# Madison Metro Transit System

April 20, 2006

TO: Plan Commission  
FROM: Timothy Sobota, Transit Planner, Metro Transit  
SUBJECT: **5702 Raymond Road – Walgreens at Meadowood Plaza**

**1 SITE PLAN**  
 1"=30'-0"

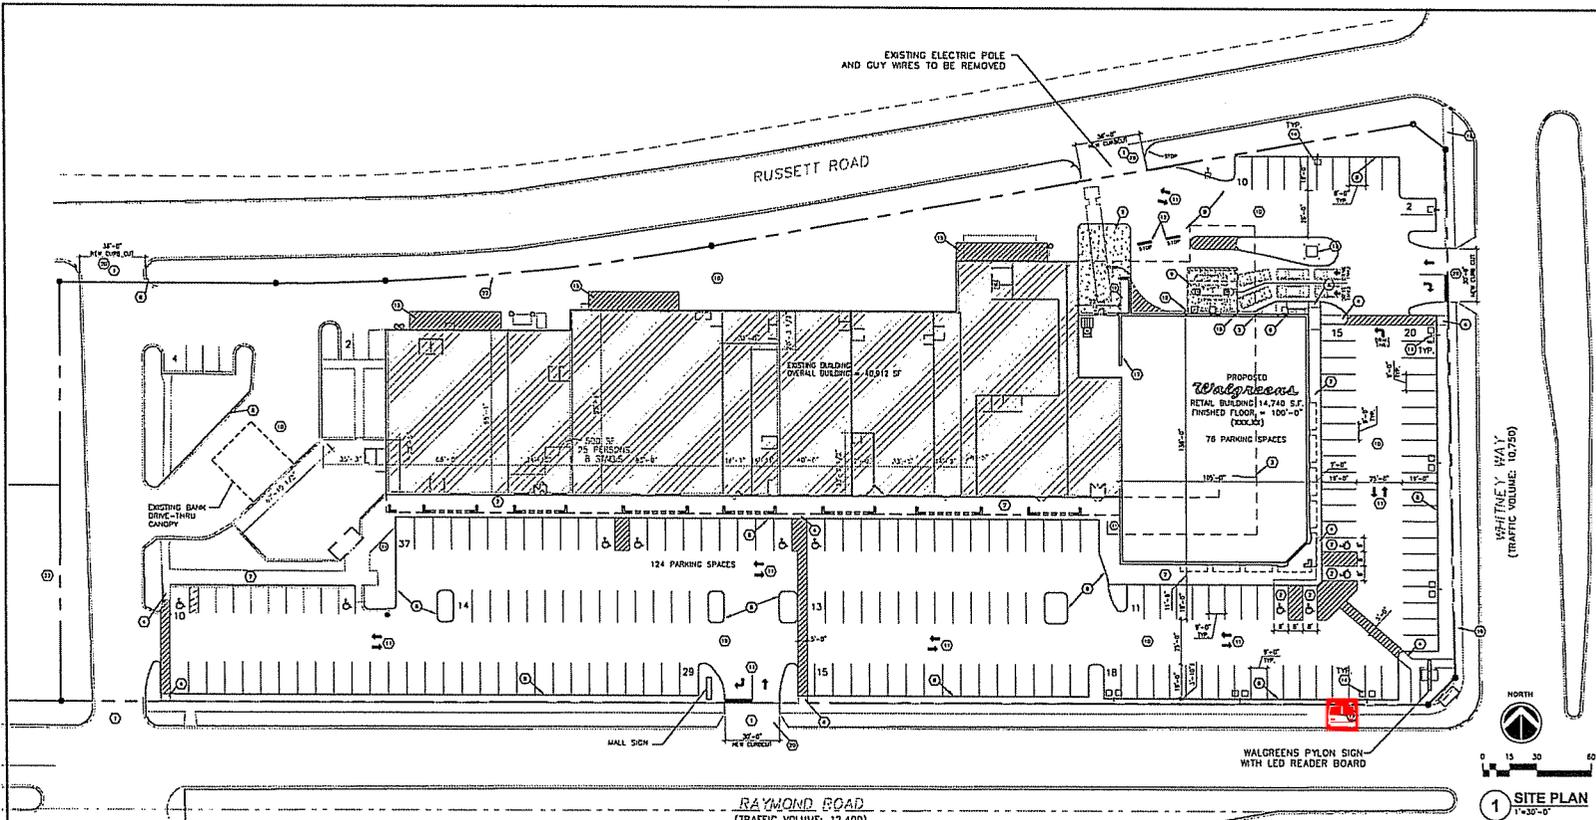
1. The applicant shall install a concrete passenger boarding pad on the north side of Raymond Road, approximately 100 feet west of Whitney Way, within the area of the driveway apron proposed to be abandoned. The concrete pad shall occupy the full distance of the terrace, measure 6 feet in width parallel to the street, and lie flush between the sidewalk and the top of curb.

2. The applicant shall install and maintain a bench or other seating amenity and a trash receptacle on top of a concrete pad or other suitable surface on the north side of Whitney Way west of Whitney Way, in an area adjacent the concrete passenger boarding pad described above. If installed on City right-of-way between the curb and sidewalk, the amenities may not obstruct a six-foot zone of concrete pad between the curb and sidewalk on the west end, furthest from the intersection.

3. Such passenger amenity requests are typically fulfilled with the applicant installing the items on private property behind the sidewalk. It is Metro Transit's recommendation that the applicant review the potential of placing the amenities outlined above on private property. **Placement of privately installed and maintained property on public right-of-way will require the review and approval of additional City agencies, including City Real Estate and City Engineering, prior to Metro Transit giving final approval to the plans.**

4. The developer shall include the location of these passenger amenities on the final documents filed with their permit application so that Metro Transit may review and approve the design.
